This Service Information bulletin supersedes SI 18 06 12 dated August 2012.

Voluntary Emissions Recall Campaign 11E-A03: Replace the SCR Mixer

E70 and E90 with the M57Y engine

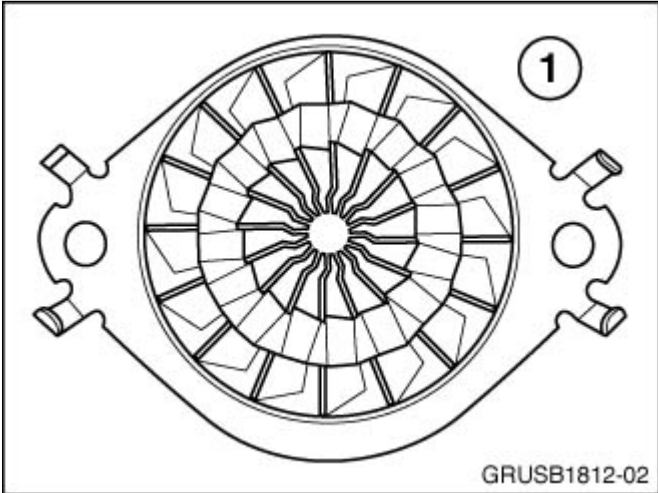
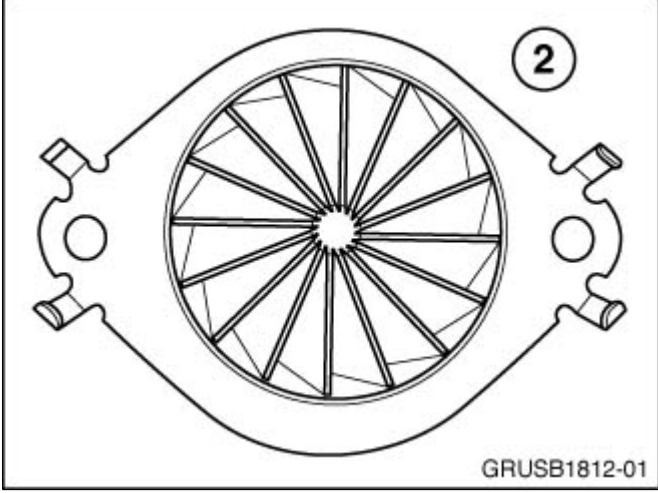
<p>GRUSB1812-02</p>	<p>The original style mixer has a multiple fin arrangement (1). This mixer will need to be replaced with P/N 18 30 8 513 445 (E70) or P/N 18 30 8 512 438 (E90).</p>
 <p>GRUSB1812-01</p>	<p>The updated mixer has one set of fins (2).</p>
	<p>The mixer for the E90 (1) is shorter than the mixer for the E70 (2).</p>

Replace the mixer (Repair instruction 18 31 140).

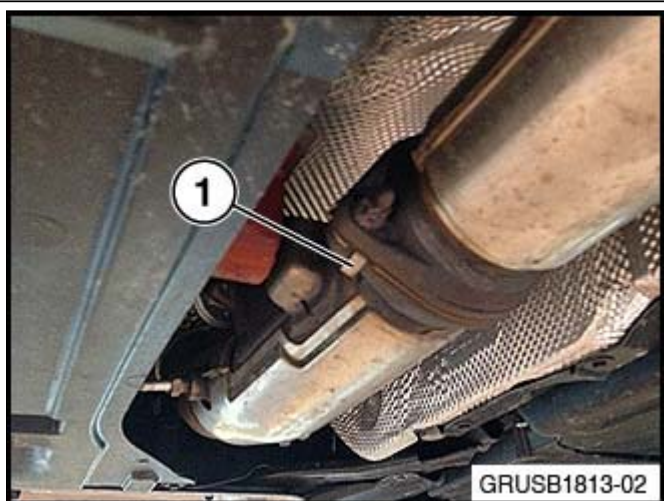
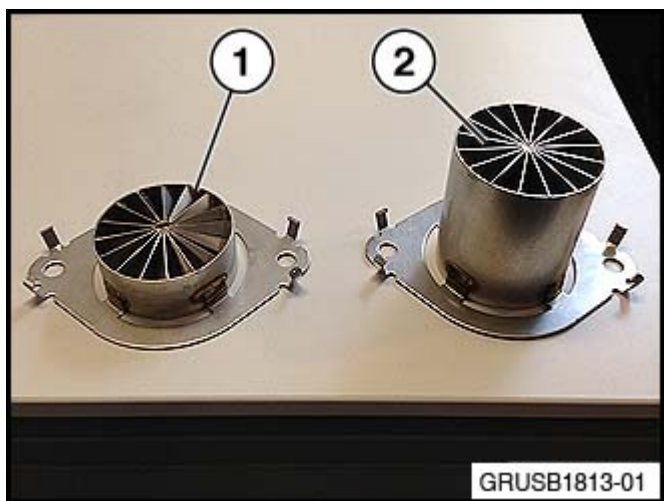
The barrel of the E70 mixer points toward the front of the car. This is easily identified by the mixer tabs wrapped around the front pipe flange (1).

The barrel of the E90 mixer points toward the rear of the car. This is identified by the mixer tabs wrapped around the flange on the SCR cat (1).
